Westinghouse  
Electric Corporation

NTD-NRC-94-4236  
DCP/NRC0162  
Docket No.: STN-52-003

SUBJECT: WESTINGHOUSE RESPONSES TO NRC REQUESTS FOR ADDITIONAL  
INFORMATION ON THE AP600

NTD-NRC-94-4236  
 ATTACHMENT A  
 AP600 RAI RESPONSES  
 SUBMITTED JULY 25, 1994

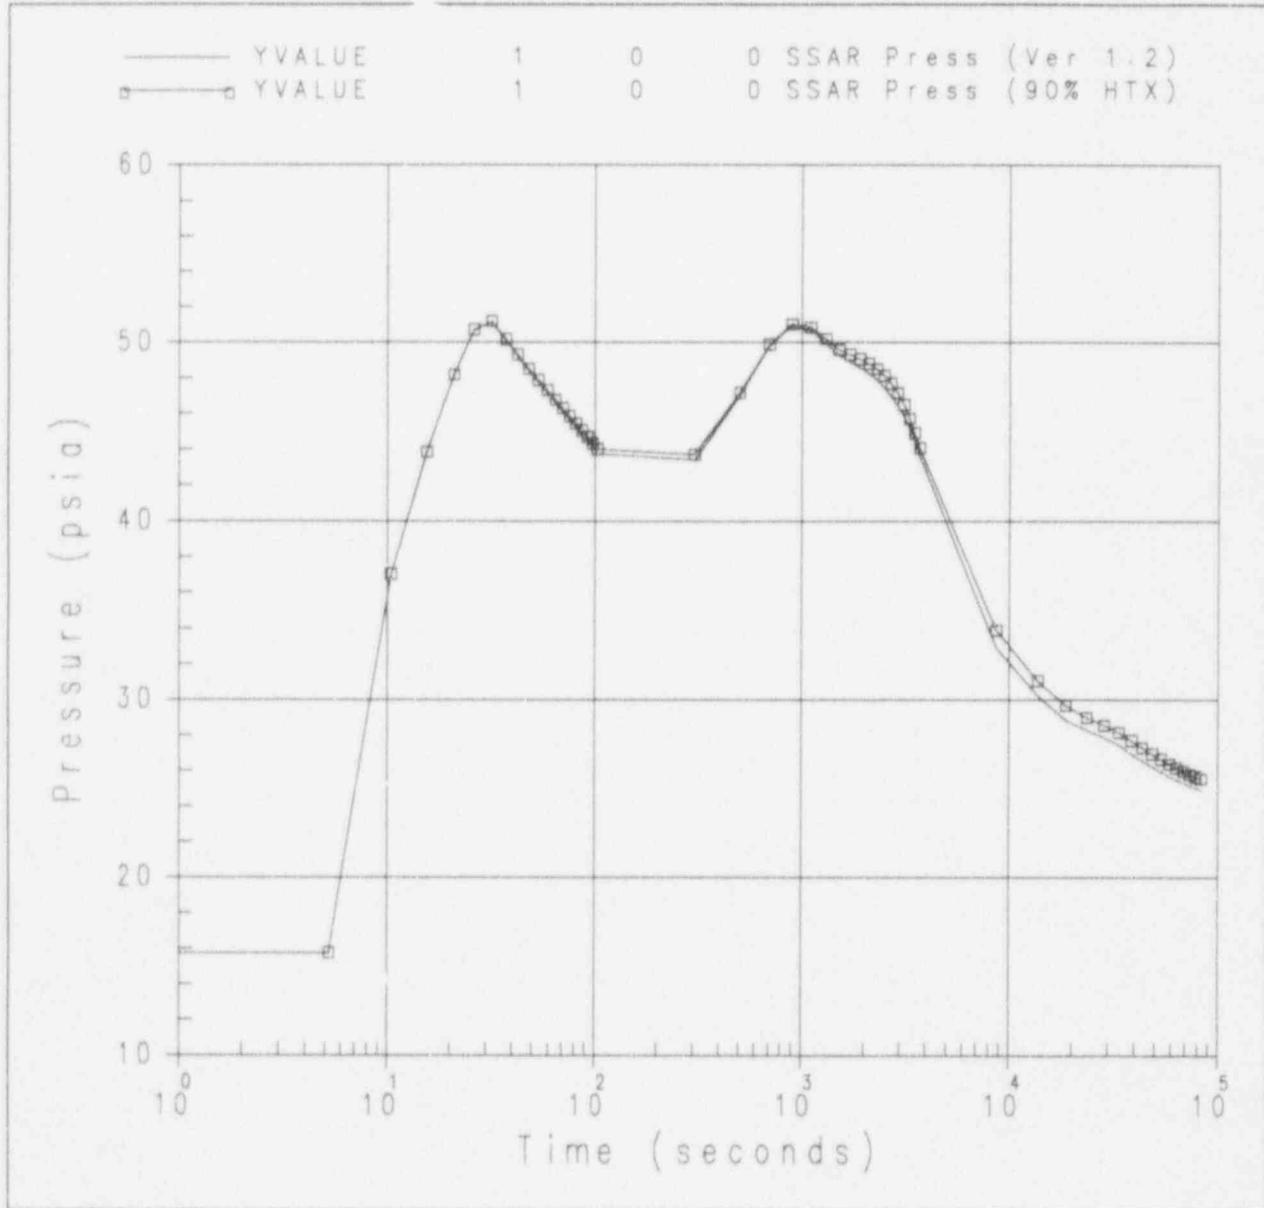
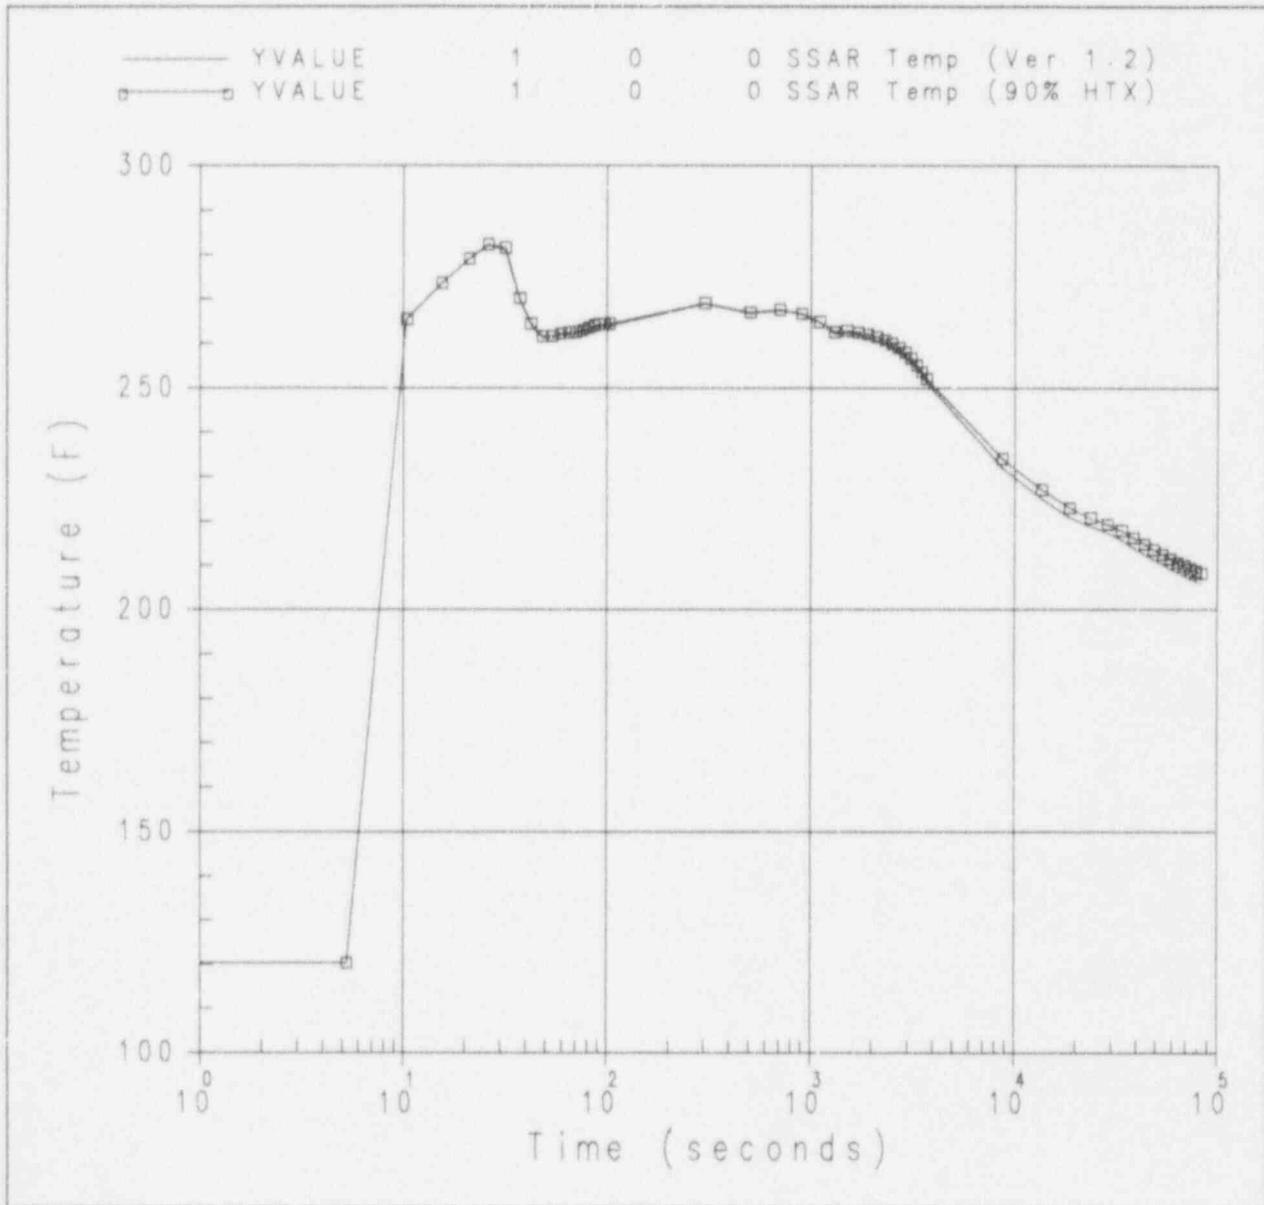
Question 480.66

- a. What is Westinghouse's position relative to required margin between maximum calculated and design pressure? If none is considered, then how does Westinghouse ensure there will be no differences between the current design stage and the "as built" of the actual plant.
- b. Provide justification for using best-estimate heat transfer coefficients in DBA calculations. Provide an uncertainty analysis for the worst case DBA accident that takes these heat transfer coefficients into account.
- c. The staff understands that other parameters that are inputs to the DBA calculations are conservative, specifically boundary conditions and initial conditions such as input mass and energy release rates. Confirm this understanding.

- b. The heat transfer correlations used in the design basis analysis calculations are taken from open literature and applied via the Westinghouse-GOTHIC code. The free convection component of the heat transfer correlation is calculated using the McAdams correlation. The Colburn correlation is used for natural convection heat transfer that is better represented by a forced convection heat transfer coefficient due to higher steam/air velocities. These correlations are applied directly; however, there is the capability to apply heat transfer coefficient multipliers to the calculation. To demonstrate the sensitivity to an uncertainty of 10%, the limiting loss of coolant accident case was reanalyzed. The heat and mass transfer coefficients were reduced to 90% of the calculated value and the transient was rerun. The reduction in the heat transfer coefficient should not affect the blowdown peak pressure, but should cause the containment pressure and temperature to increase later in the transient.

The containment pressure and temperature response calculated with the reduced heat transfer coefficients has been plotted and compared with the limiting loss of coolant accident case. The peak containment pressure (which occurs at the end of blowdown) increased by 0.05 psi and the containment pressure at 24 hours increased by 0.6 psi (and is still less than half the containment design pressure).
